To: City Council
From: Planning and Zoning Commission
Date: June 26, 2017
Re: Case #17016 -Cunningham at Creekmoor
Second Final Plat - Lots 69 through 104 and
Tracts E and F

Outline of Requested Action: The applicant seeks to obtain Final Plat approval for the Cunningham at Creekmoor Second Final Plat – Lots 69 through 104 and Tracts E and F.

To: Planning and Zoning Commission
From: Edward Ieans, Assistant Public Works Director
CC: File
Date: May 31, 2017
Re: Final Plat: Cunningham of Creekmoor, Second Plat: Lots 69 Through 104, Tract E and F

Illustration of the changes to the preliminary plat

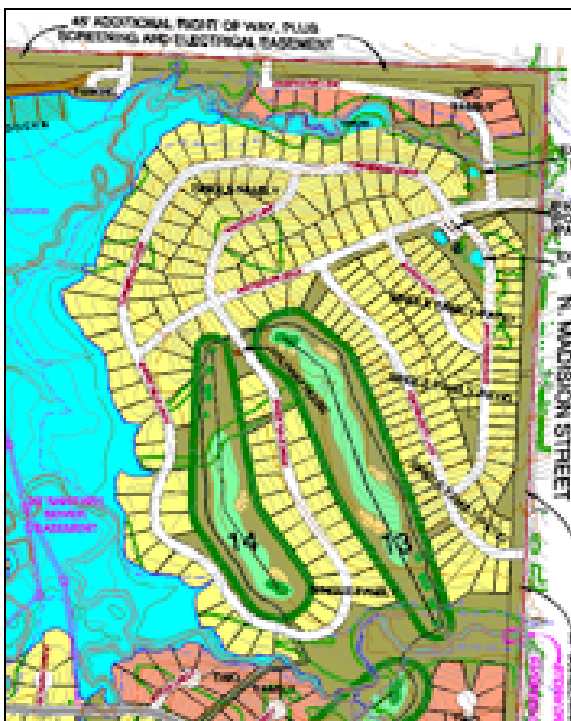
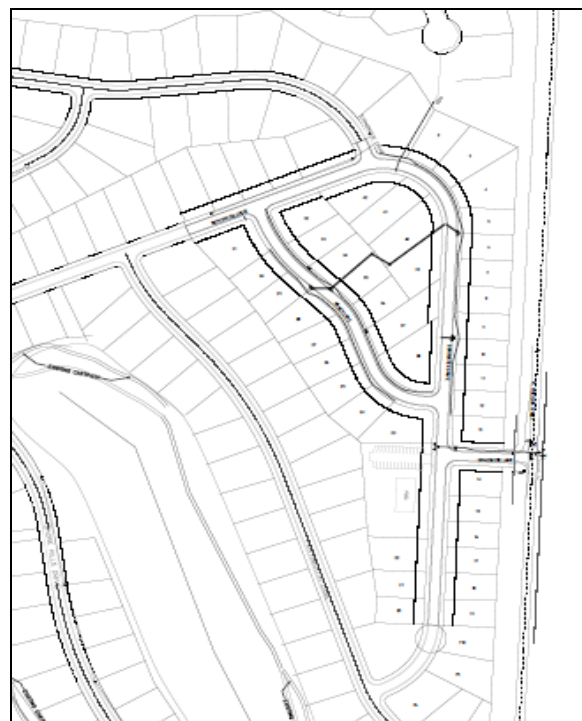
- The proposed final plat is slightly modified from the approved preliminary plat. The preliminary plat showed Bentwater Drive (part of the 1st plat) as the primary entrance into the Cunningham subdivision from N. Madison Street. That entrance has been relocated south with the addition of Granshire Lane.

- The pool has been relocated from the location indicated on the preliminary plan. The pool will be located in the open space at the southwest corner of Granshire Lane and Bentwater Drive.
- The street names and roadway alignments shown on the preliminary plat have been changed slightly to reflect the vacation of the First plat.
- Tract E and Tract F are located on the eastern perimeter of the subdivision providing a buffer along North Madison Street.
